In the United States Patent and Trademark Office

Applicant(s) Douglas B. Wilson
Serial No. 10/727,306
Confirmation No.: 5202
Filed 12/03/2003
Title FATIGUE RELIEVING SUPPORT FOR STEERING WHEELS AND
THE LIKE
Examiner Vinh Luong
Unit 3682

APPEAL BRIEF UNDER 37 C.F.R. §41.37

ATTACHMENT # 1

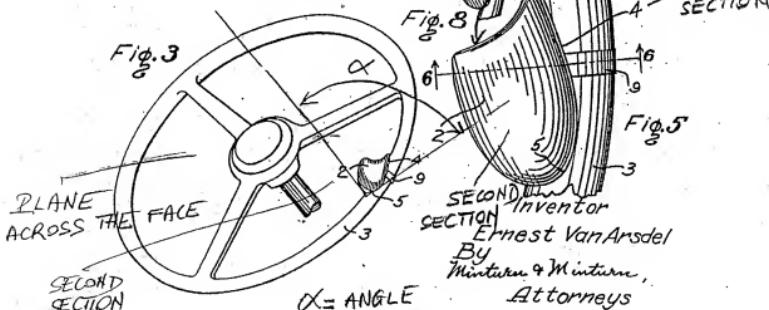
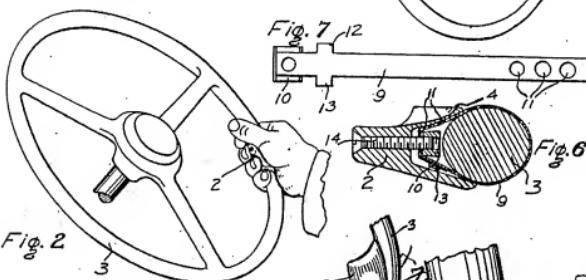
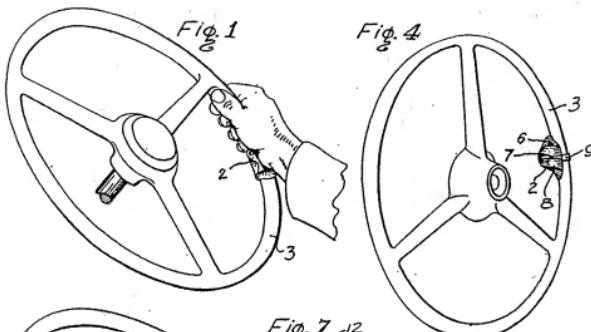
The instant Office action only uses Laubach, Anson, and Van Arsdel. Each of these references teaches the second section disposed outward at an angle to the plane across the face of the steering wheel as seen in Attachments 1-3. Therefore, the elected claims 14-19, 24/14 and 27

A review of Figures 3 and 5, as annotated by the Examiner, attempts to show that the grip-rest of Van Arsdel is disposed outward at an angle α to a plane across the face of the steering wheel shows that the Examiner's position is misplaced. As the description above from Van Arsdel indicates, the grip-rest is disposed as shown in Figure 6 parallel to the plane across the face of the steering wheel not at angle to it. This is very clear because in each disposition of the grip-rest in the Figures, it is fixed in this parallel plane to support the thumb or part of the palm. It is also fixed so that it is not deformable so the driver can put extensive pressure on it (and it will not move) for steering the automobile (See underscored sections in the quotation above).

ATTACHMENT # 2

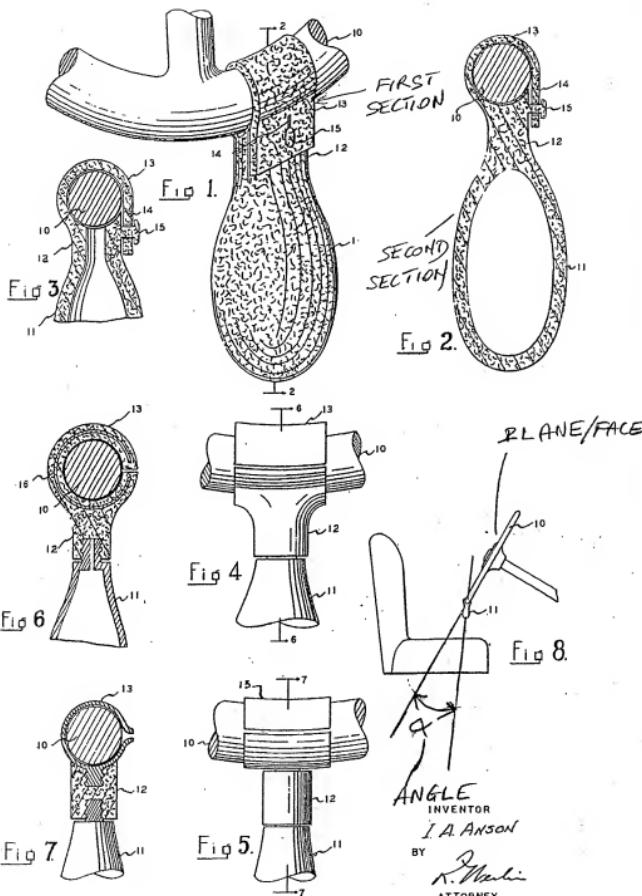
The Examiner has rejected claims 14-17, 19/17, 24/14, and 27 for anticipation based on Anson. Referring to the Figures of Anson, the Examiner states that reference no. 13 equates to the first section and reference no. 11 equates to the second section of claim 14. The Examiner has annotated Figure 8 to indicate that the steering wheel attachment of Anson is disposed at an angle α with respect to a plane across the face of

Fig. 1.

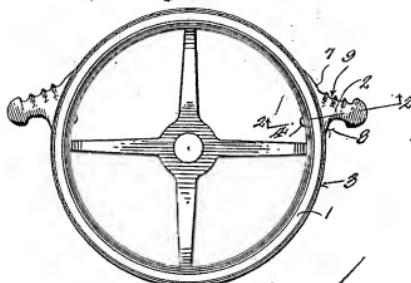
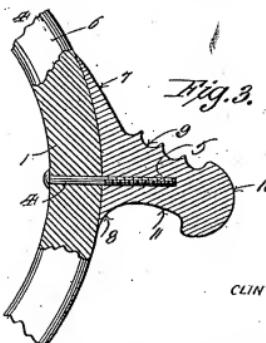
The Examiner rejected 14, 18, and 19/18 for anticipation based on Laubach. The Examiner relies on the Examiner-annotated version Figure 2 of Laubach and indicates that reference nos. 7 and 8 equates to the first section and reference no. 10 equates to the second section of claim 14.¹⁴ Appellant submits that Laubach does not form a *prima facie* basis of anticipation becausc at least one element is missing.

The description of the knobs and a review of the Figures makes plain that the knobs are not deformable and they are not disposed at an angle with respect to the plane across the face of the steering wheel. The knobs are rigidly connected to the steering wheel by screws 5. Any movement of them requires removing the screws, drilling the wheel at a new location, and reattaching the knobs at the new location. At this new location, the knobs will be in a plane parallel to the plane across the face of the steering wheel.

ATTACHMENT 1

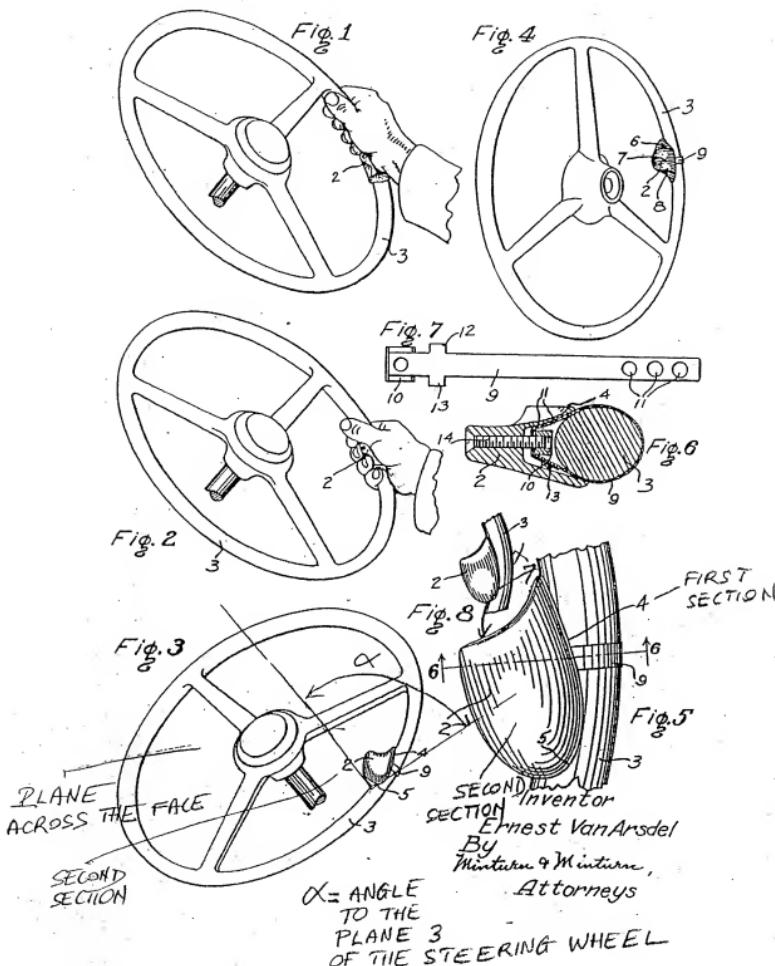
A review of Figs. 3 and 5 as announced by the Examiner to attempt to show that the auto steering wheel handgrip of Van Arsdel is disposed at an angle α to a plane across the face of the steering wheel shows that the Examiner's position is misplaced. As the description above from Van Arsdel indicates, *the auto steering wheel handgrip is disposed as shown in Figure 6 parallel to the plane across the face of the steering wheel not at angle to it*. This is very clear because in each disposition of the auto steering wheel handgrip in the Figures, the handgrip is fixed in this parallel plane to support the thumb or part of the palm. *It is also fixed so that it is not deformable so the driver can put extensive pressure on*

steering wheel rim 3 in a manner to slope downwardly and inwardly of the rim. The outer edge 4 of the side, and 5 of the rear end of the *concave*, located above the rim, *extends up into a marginal flange* to be contacted by the inside of the ball of the thumb or by the bottom of the hand, depending upon which part of the hand is seated to rest." See also Arsdel's claims 1 and 2. Arsdel's concave upward section 2 extends from the first section 4 outward at an angle α to the plane across the face of the steering wheel as seen in Figs. 3 and 8 of Attachment 1. Therefore, Arsdel's concave upward section 2 in Fig. 3 of Arsdel "reads on" Applicant's claimed second section.

ATTACHMENT 2

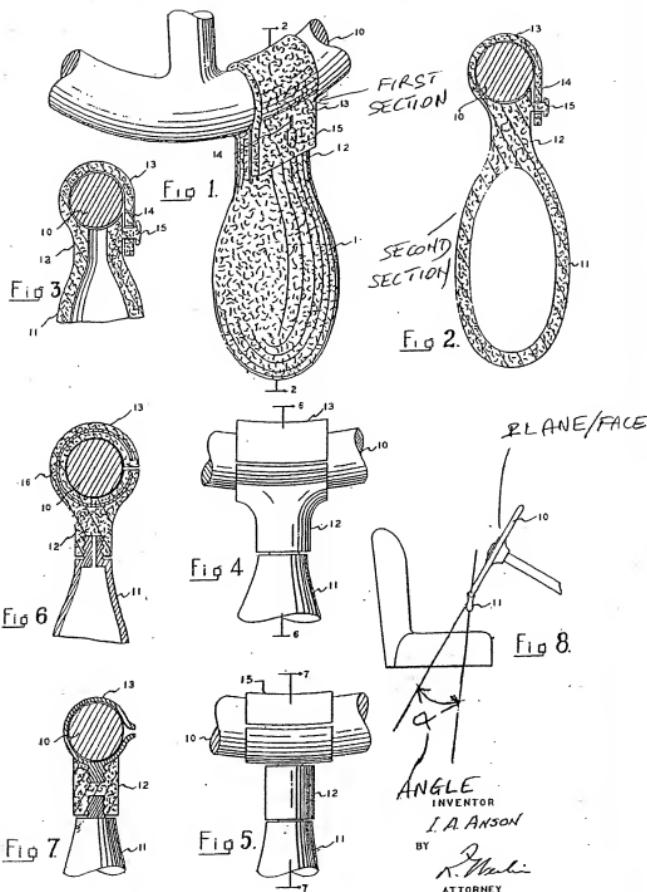
a first section 13 that connects to a peripheral portion of the steering wheel 10;
a second section 11 extends from the first section at the peripheral portion of the steering wheel 10, the second section 11 extends from the first section 13 outward at an angle (see angle α in Fig. 8 of Attachment 2) to a plane (Att. 2) across a face (Att. 2) to the steering wheel 3, the second section 11 inherently for supporting at least a portion of a vehicular operator's body (e.g., the hand) when pressure from the portion of the vehicular operator's body on the second section 11 is less than the pressure for deforming the second section 11 out of interference with the vehicular operator's ability to operate the steering wheel 10, and deforming out of interference with the vehicular operator's ability to operate the steering wheel 10 when pressure from the portion of the vehicular operator's body on the second section 11 is equal to or greater than the pressure for deforming the second section 11 out of interference with the vehicular operator's ability to operate the steering wheel 10.

Fig. 1.

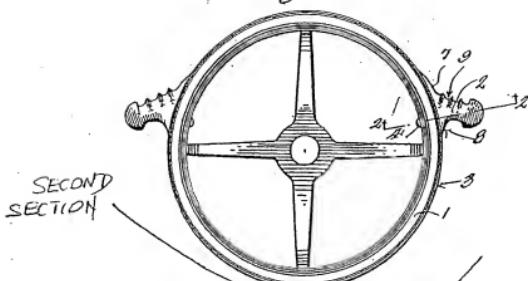
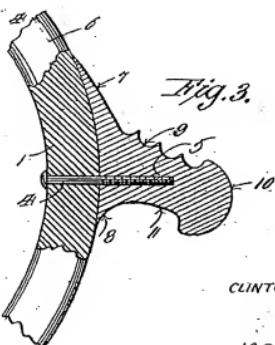
a second section 10 that connects to, and extends from, the first section 7, 8 at the peripheral portion of the steering wheel 1, the second section 10 extends from the first section 7, 8 outward at an angle (see angle α in Fig. 2 of the Attachment 3) to a plane (Att. 3) across a face (Att. 3) to the steering wheel 1, the second section 10 inherently for supporting at least a portion of a vehicular operator's body (e.g., the hand) when pressure from the portion of the vehicular operator's body on the second section 10 is less than the pressure for deforming the second section 10 out of interference with the vehicular operator's ability to operate the steering wheel 1, and deforming out of interference with the vehicular operator's ability to operate the steering

Applicant further asserted that the Examiner's drawings to attempt to show the enlarged head 10 is disposed outward at an angle from the plane across the face of the steering wheel is unsupported. Applicant's instant assertion is in direct conflict with the substantial evidence presented in Laubach's Fig. 2. This Fig. 2 shows that the second section of Laubach forms an angle with the face of the steering wheel as seen in Attachment 3. Note that things clearly shown

ATTACHMENT 1

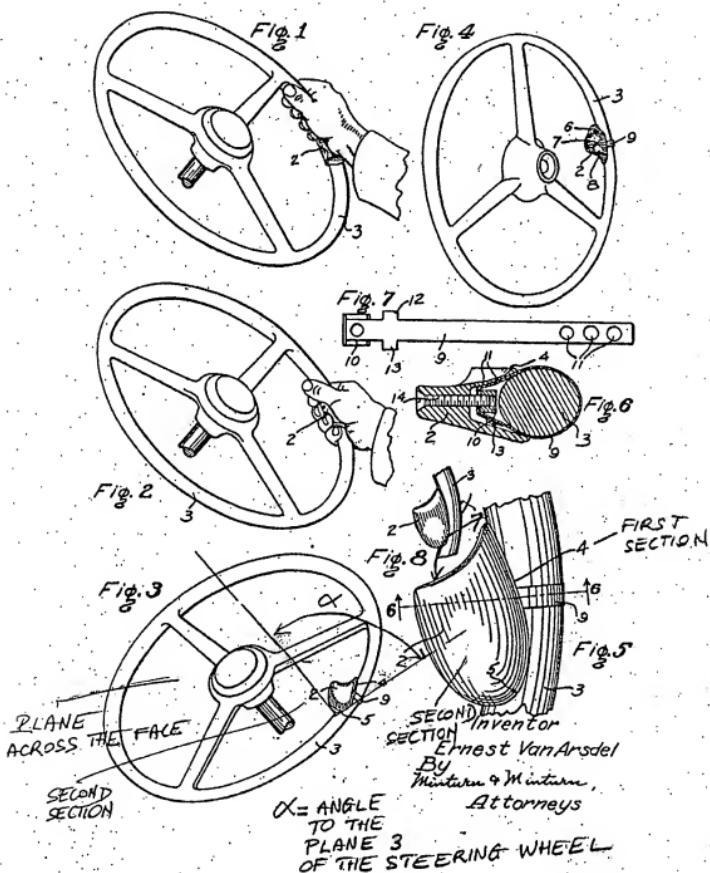
a rigid, semi-rigid or flexible, or non-deformable second section 2 that connects to, and extends from the first section 4 at the peripheral portion of the steering wheel 3, the second section 2 extends from the first section 4 outward at an angle (see angle α in Figs. 3 and 5 of Attachment 1) to a plane (Att. 1) across a front face of the steering wheel 3, the second section 2 for supporting at least a portion of a vehicular operator's body when pressure from the portion of the vehicular operator's body on the second section 2 is less than the pressure for deforming the second section 2 out of interference with the vehicular operator's ability to operate the steering wheel 3, and deforming out of interference with the vehicular operator's ability to operate the steering wheel 3 when pressure from the portion of the vehicular operator's body on

I. A. ANSON
STEERING WHEEL ATTACHMENT
Filed Sept. 30, 1937

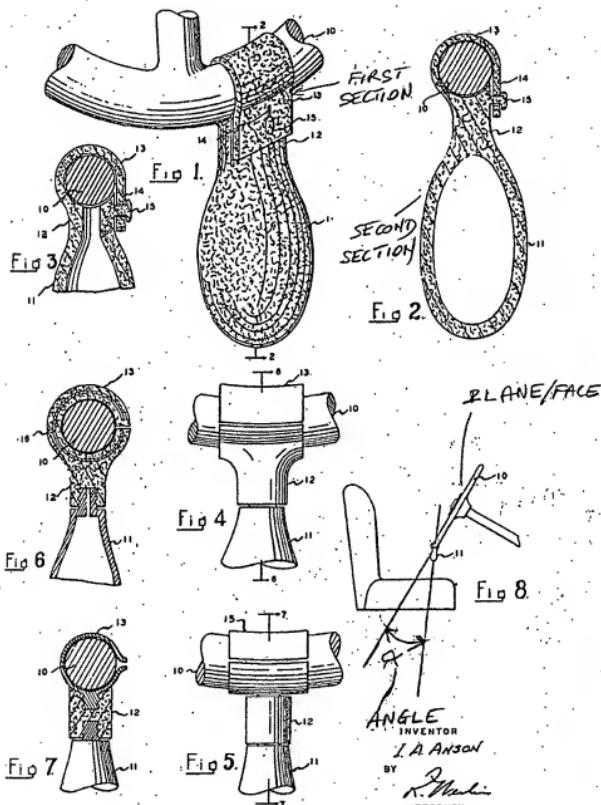
a first section 13 that connects to a peripheral portion of the steering wheel 10; and a rigid, semi-rigid or flexible, or non-deformable second section 11 that connects to, and extends from the first section 13 at the peripheral portion of the steering wheel 10, the second section 11 extends from the first section 13 outward at an angle (see angle α in Fig. 8 of Attachment 2) to a plane (Att. 2) across a front face of the steering wheel 10, the second section 11 for supporting at least a portion of a vehicular operator's body when pressure from the portion of the vehicular operator's body on the second section 11 is less than the pressure for deforming the second section 11 out of interference with the vehicular operator's ability to operate the steering wheel 10, and deforming out of interference with the vehicular operator's ability to operate the steering wheel 10 when pressure from the portion of the vehicular operator's body on the second section 11 is equal to or greater than the pressure for deforming the second section 11 out of interference with the vehicular operator's ability to operate the steering wheel 10.

Fig. 1.

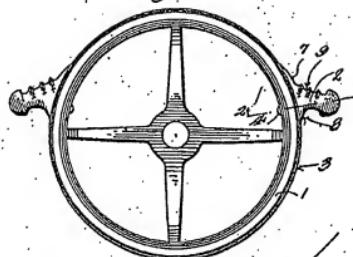
a first section 7, 8 that connects to a peripheral portion of the steering wheel 1; and a rigid, semi-rigid or flexible, or non-deformable second section 10 that connects to, and extends from the first section 7, 8 at the peripheral portion of the steering wheel 1, the second section 10 extends from the first section 7, 8 outward at an angle (see angle α in Fig. 2 of Attachment 3) to a plane (Att. 3) across a front face (Att. 3) of the steering wheel 1, the second section 10 for supporting at least a portion of a vehicular operator's body when pressure from the portion of the vehicular operator's body on the second section 10 is less than the pressure for deforming the second section 10 out of interference with the vehicular operator's ability to operate the steering wheel 1, and deforming out of interference with the vehicular operator's ability to operate the steering wheel 1 when pressure from the portion of the vehicular operator's
